ADDENDUM

AM 03

PROJECT	**: Forestside**
PROJECT #	**:** 1331.15
DATE	**:** June 30, 2020

Title: Updated drawings

P1 UNDERGROUND PLAN (OVERALL PLAN) CEILINGS

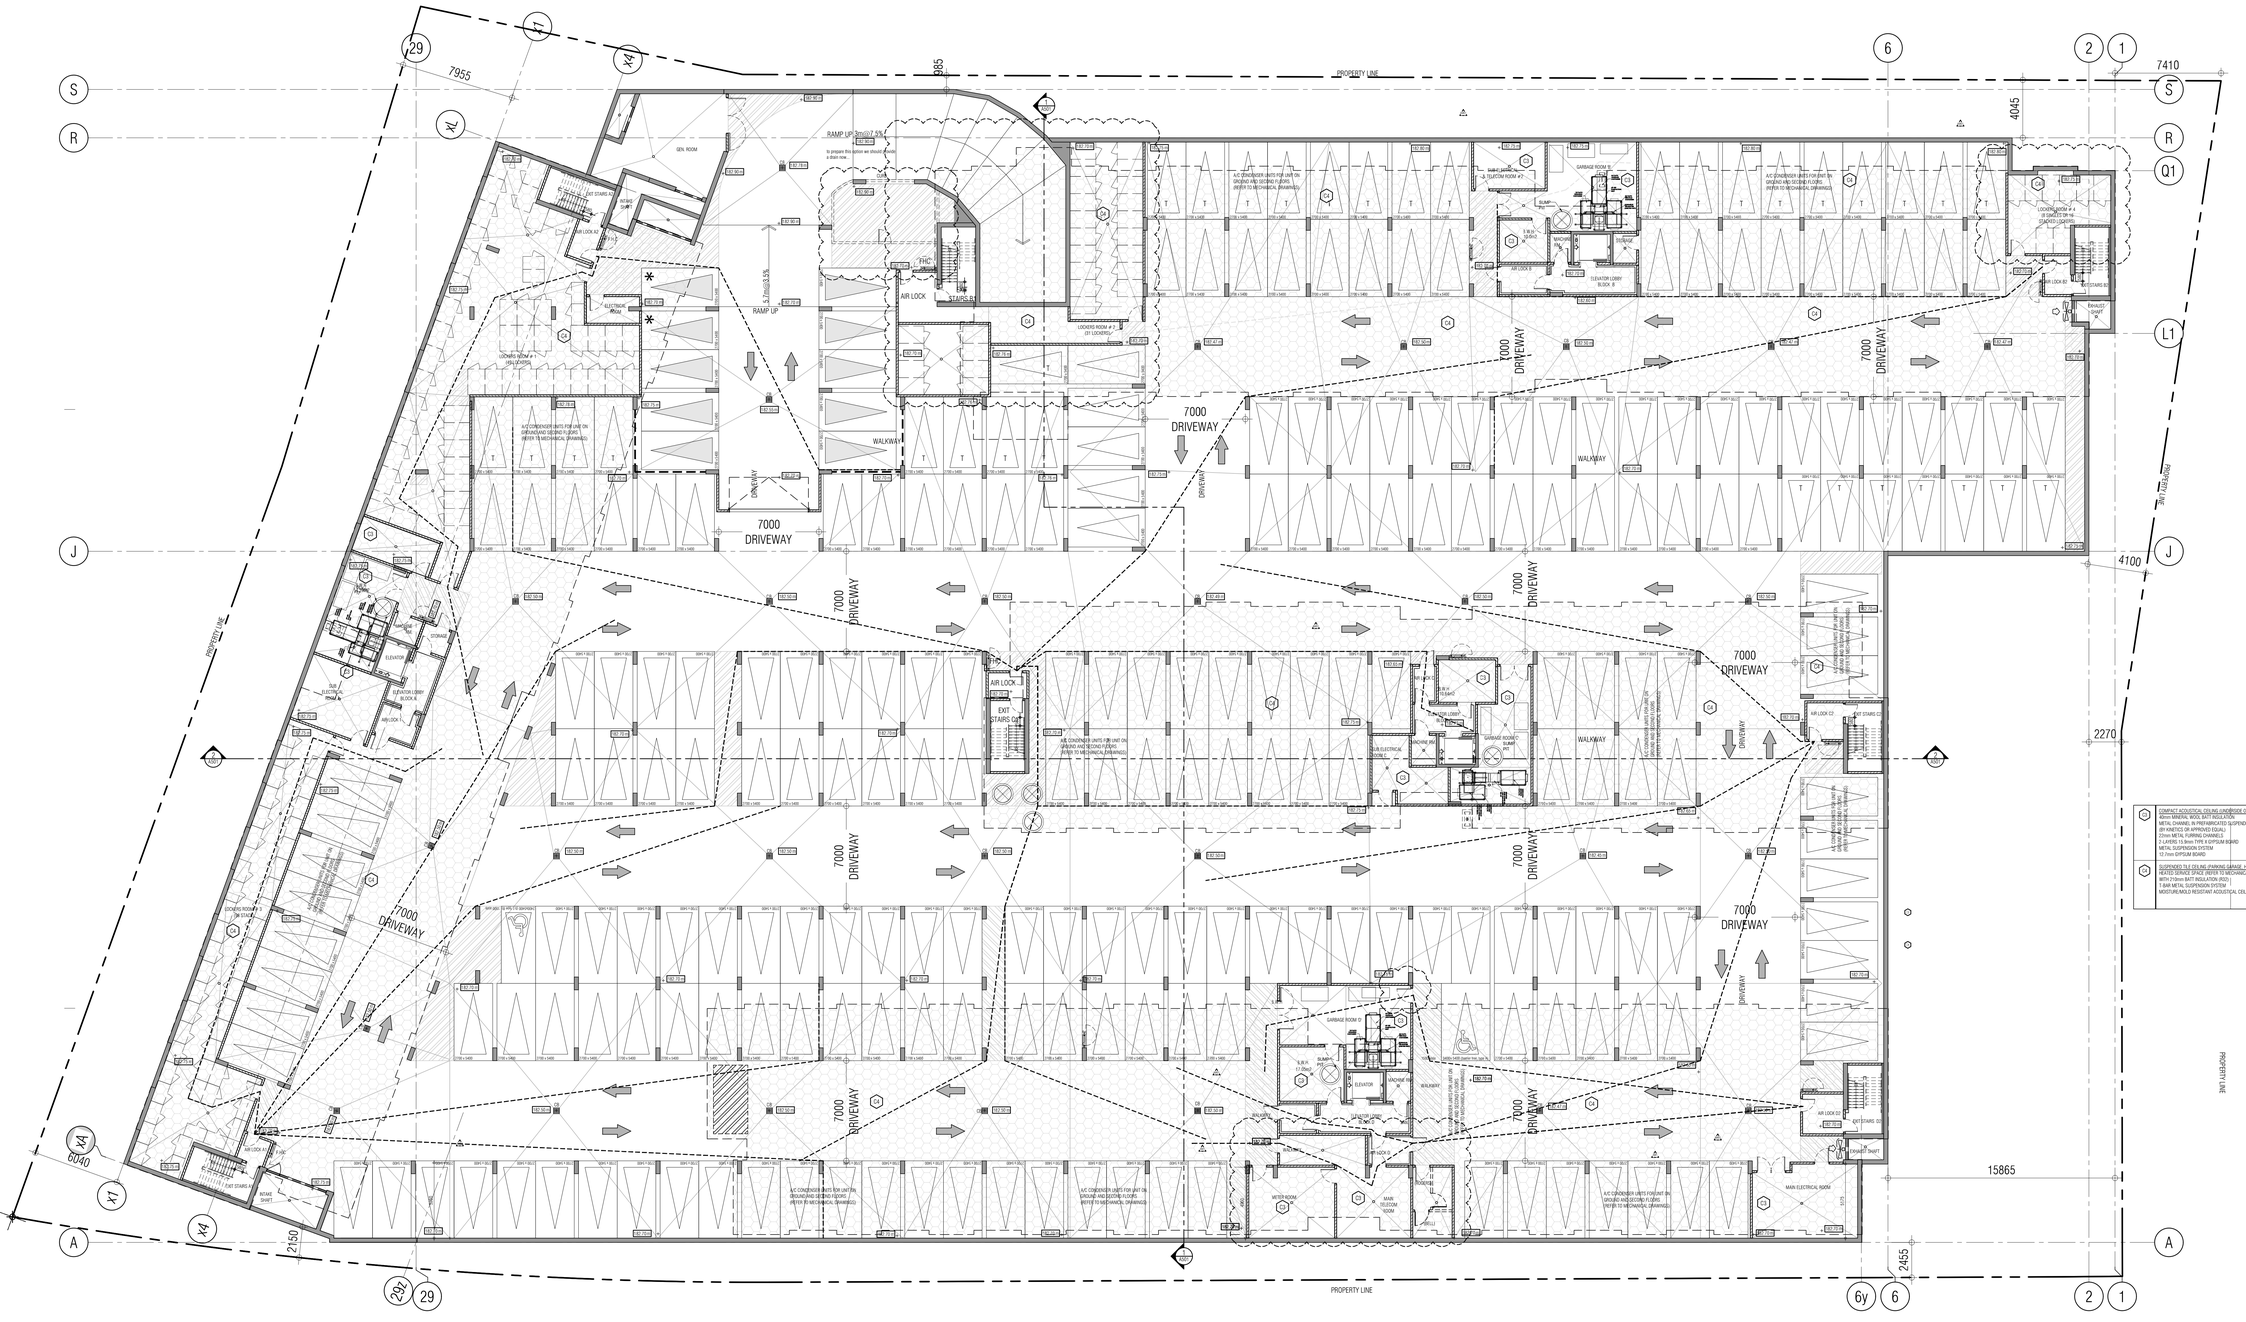
Reference:		Changes:
A-211, A-211a, A-211b	Underground P1	• Added dropped insulated ceiling outline with hatching, ceiling tag, and ceiling schedule to P1 drawings.
